INDIANA DEPARTMENT OF TRANSPORTATION

STANDARDS COMMITTEE MEETING MINUTES

RE: Minutes for the May 18, 2006 Standards Committee Meeting

402-TMPT-01, Asphalt-Pavement Wedging and Transition Milling

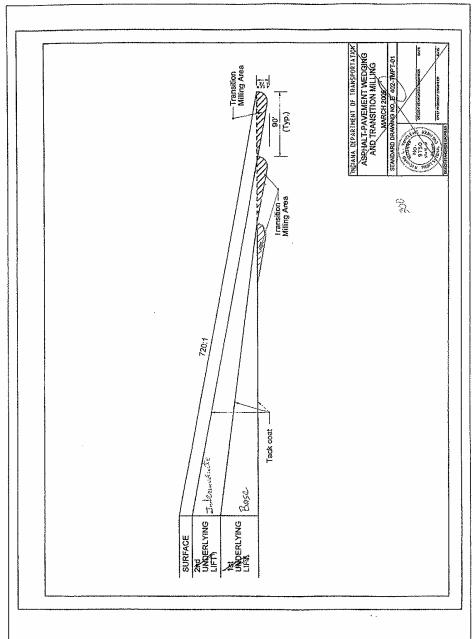
The proposed revision to the above standard sheet has been modified from what was approved at the meeting. Industry has requested a transition milling be shown for the base course as well as for the intermediate and surface courses. Dave Andrewski has agreed to this modification.

Motion: Mr. Uremovich Second: Mr. Kuchler Action: Passed as revised Effective - September 2006 Letting

Figure 72-3B, Pavement Transition Detail

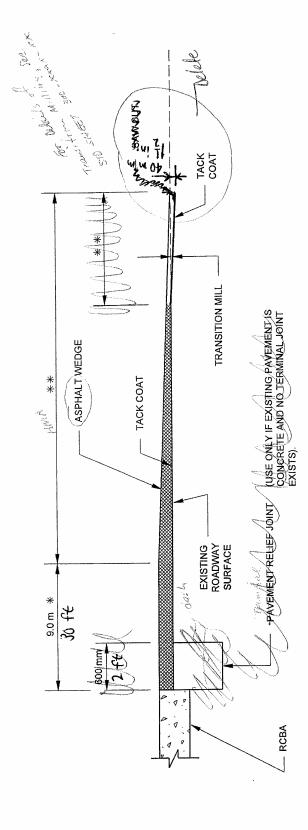
See Item 12-2

Motion: Mr. Uremovich Second: Mr. Kuchler Action: Passed as revised Effective - September 2006 Letting
